# McDONALD'S #02978 PUYALLUP 2ND

## PACIFIC NORTHWEST REGION

SHEET NO.: CVR COVER SHEET

SHEET NO: **C1.1**  
 EX. CONDITIONS & TESC PLAN

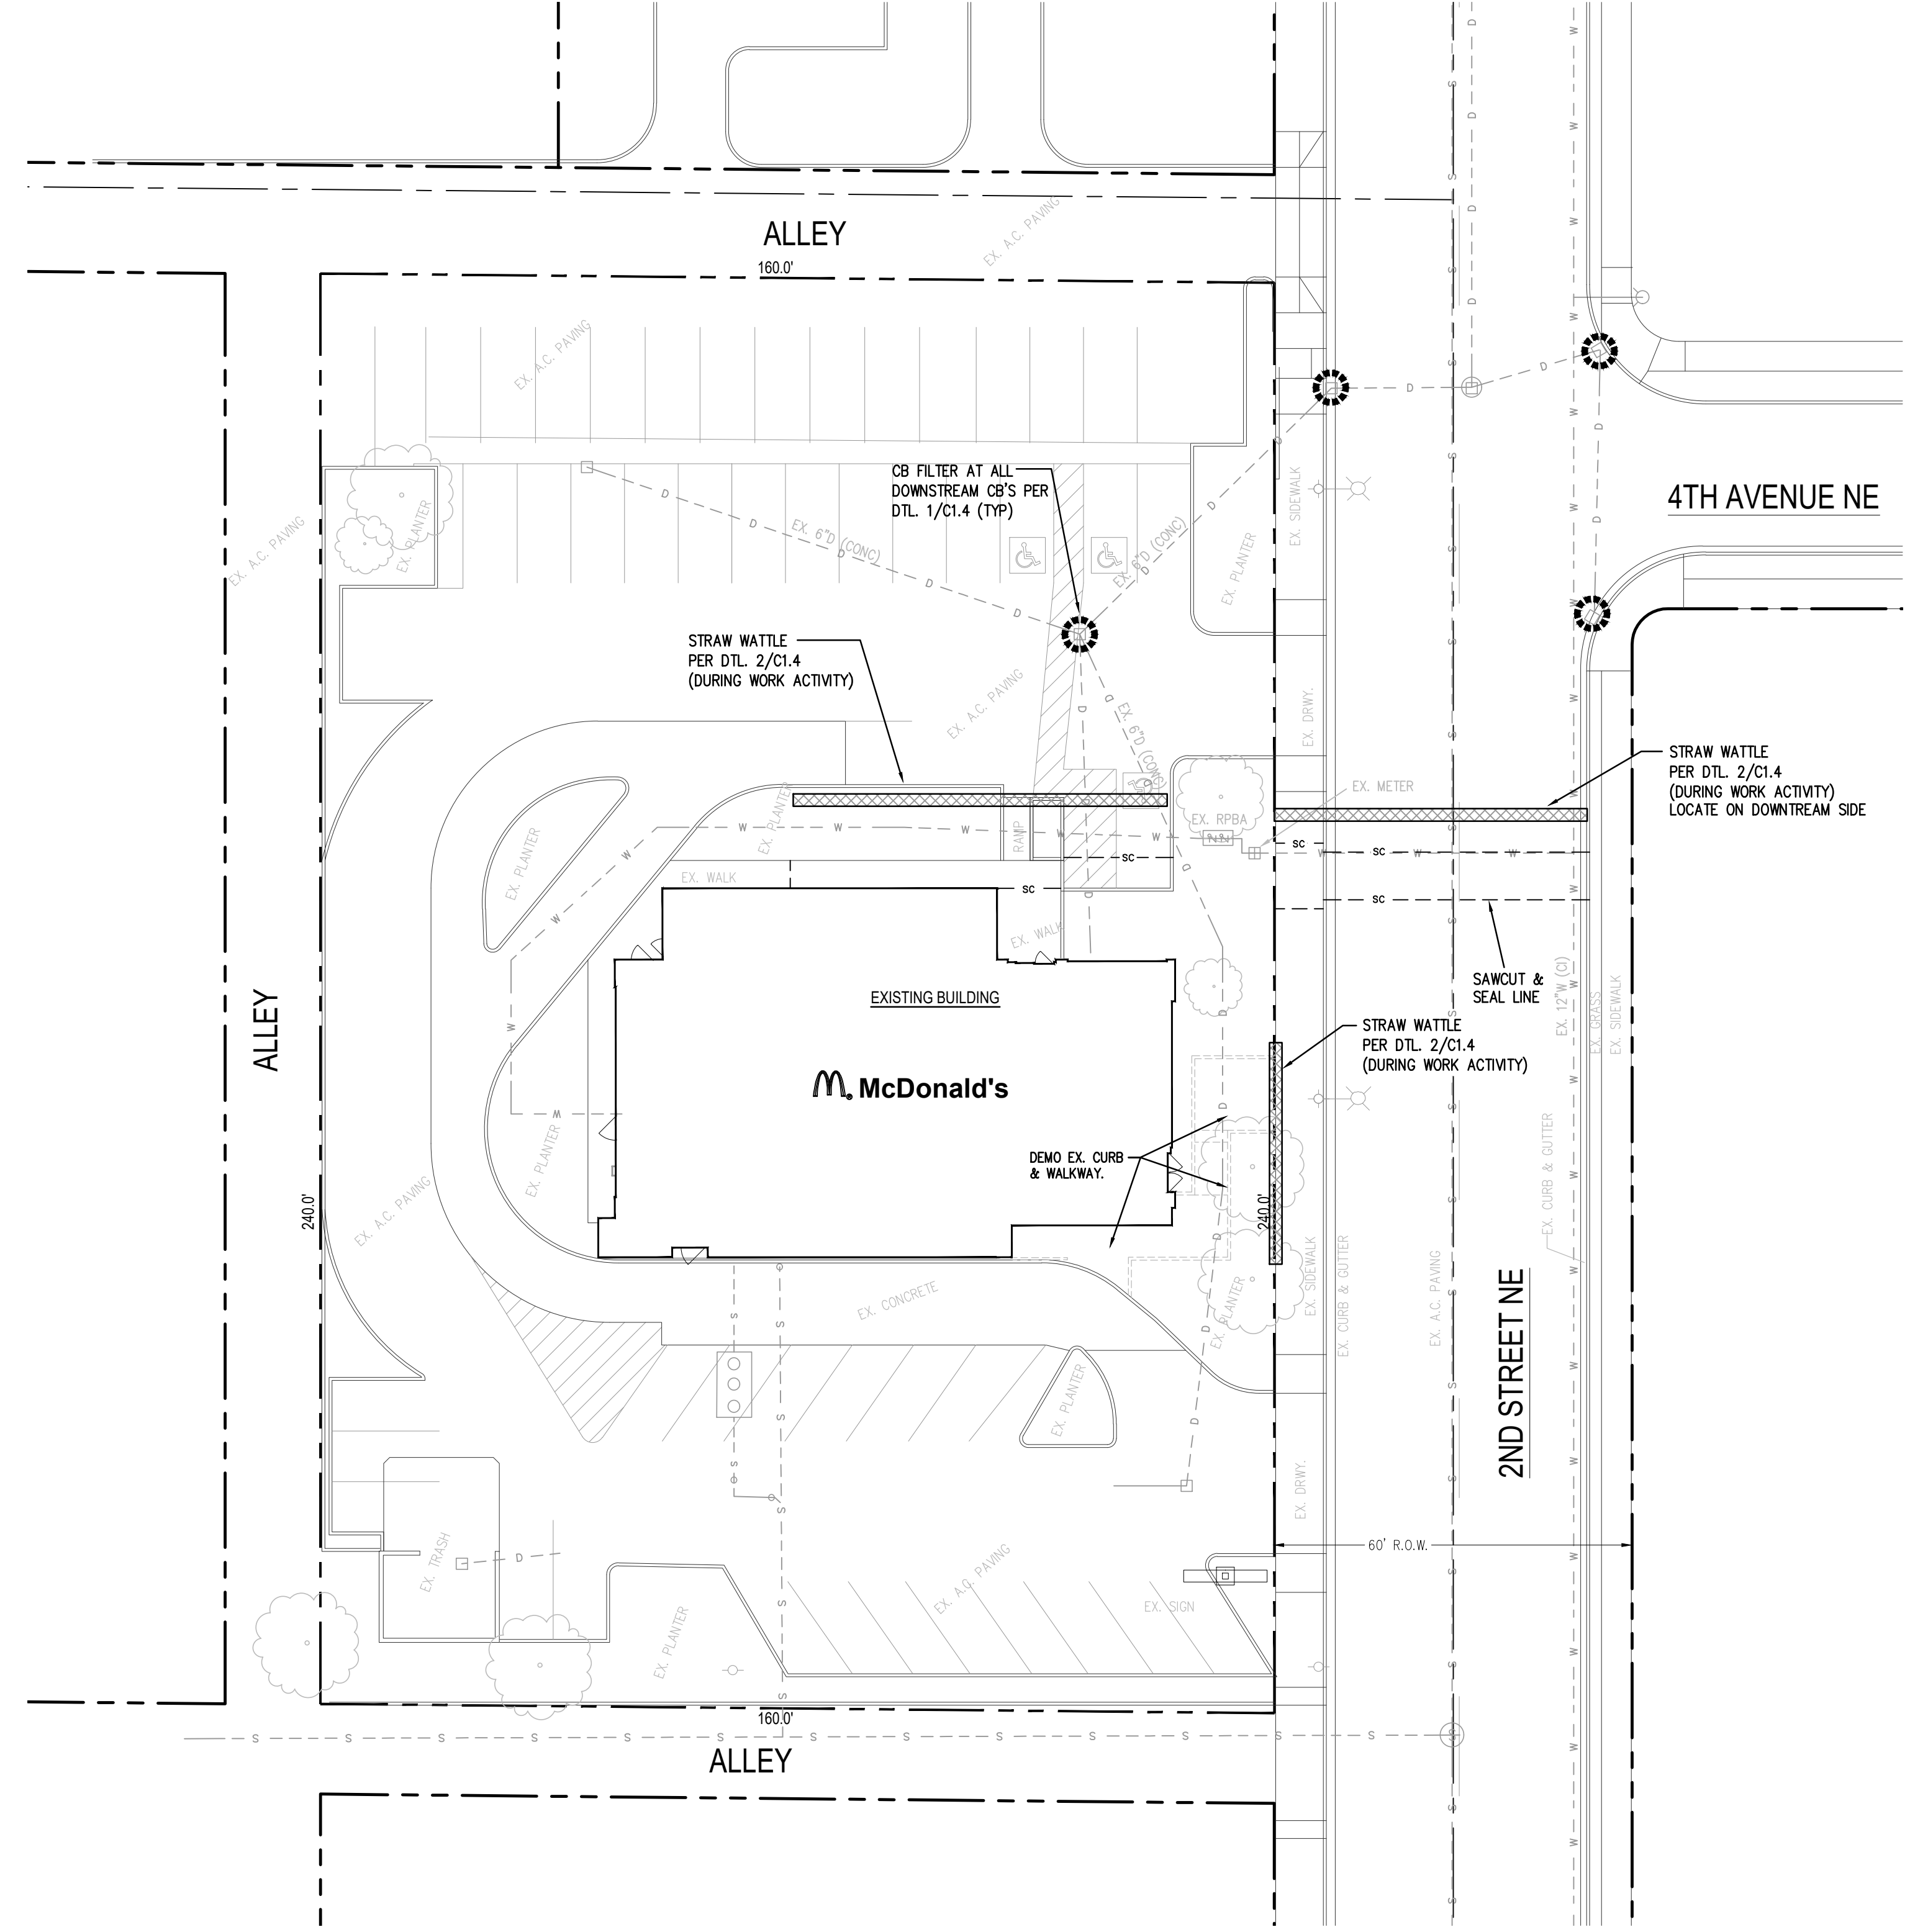
Civil work has not been reviewed or approved under building permit PRCTI20231634. Please submit all civil plans for review via a Civil Construction permit application

C1.2  
WATER PLAN & RESTORATION

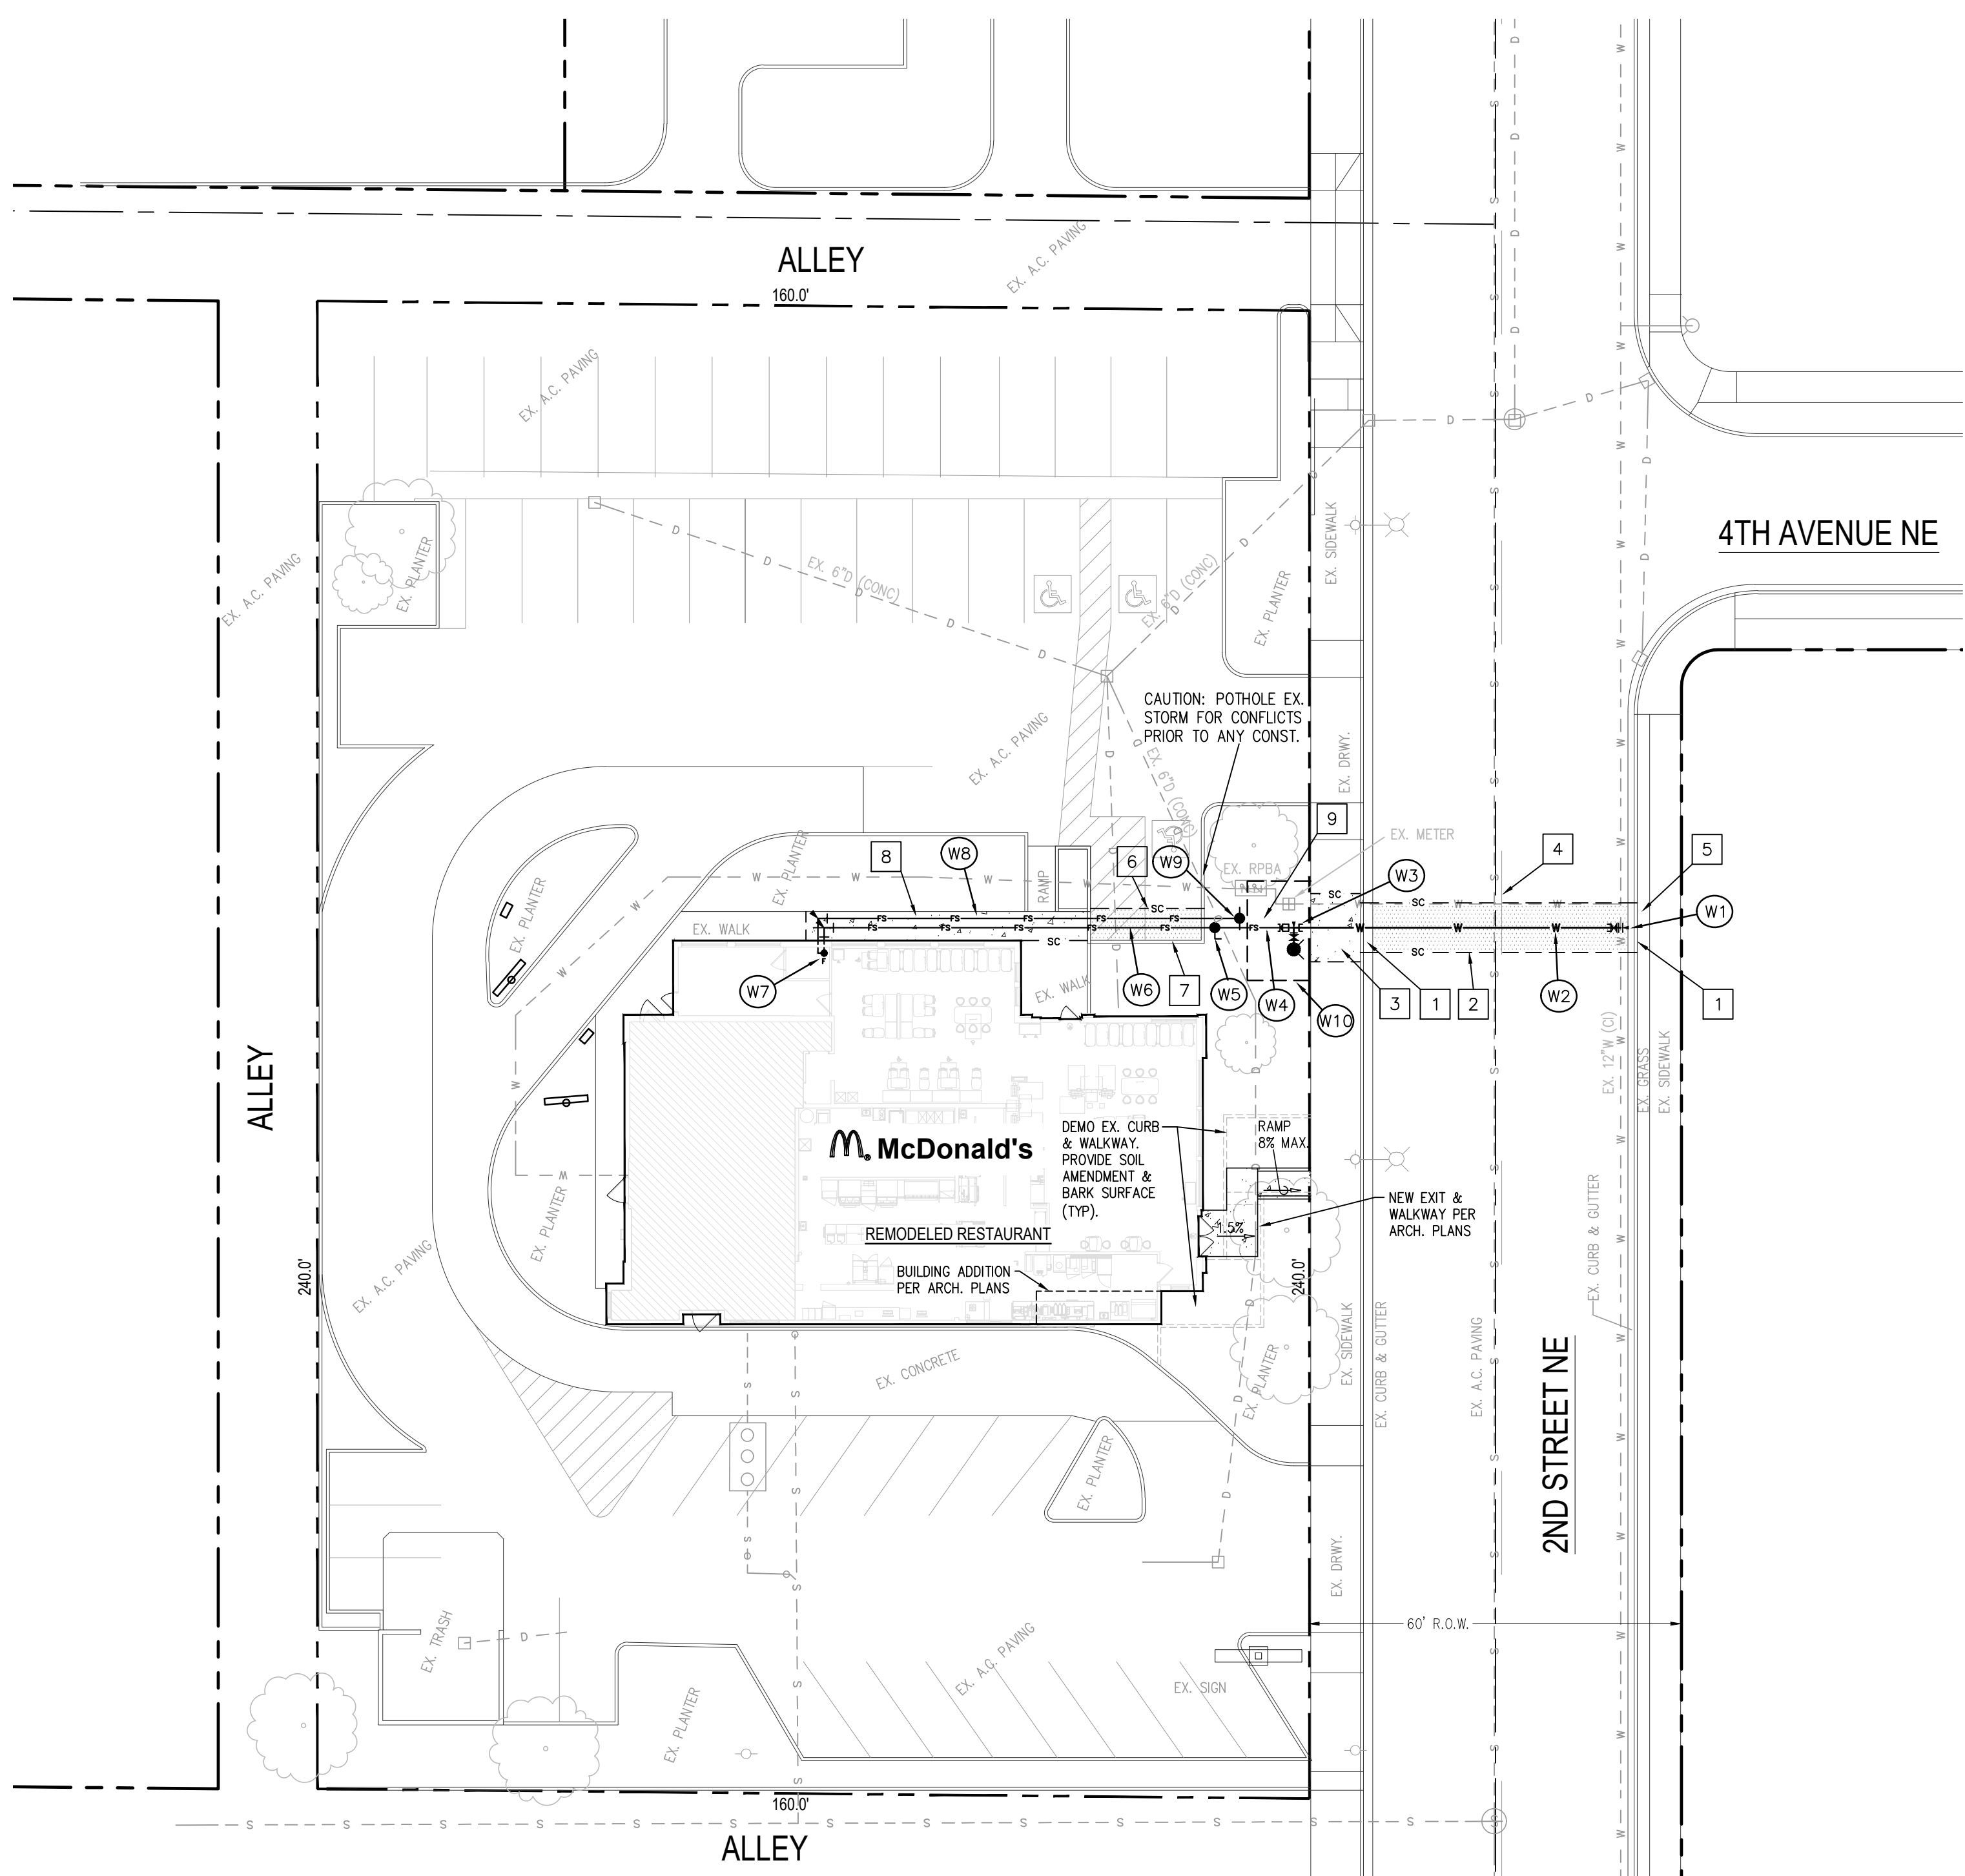
Civil work has not been reviewed or approved under building permit PRCTI20231634. Please submit all civil plans for review via a Civil Construction permit application
